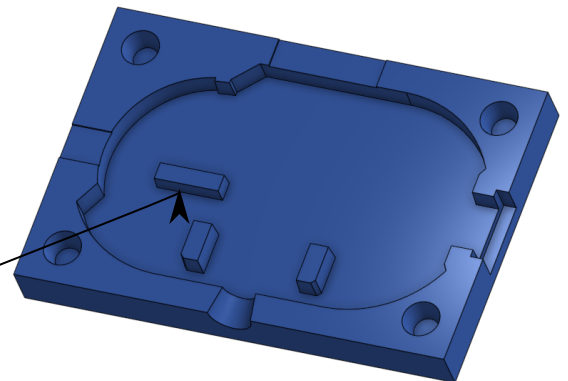
Retention on pcb edge isn't accurate enough

Leave a hole, will need to cast a silicone gasket here
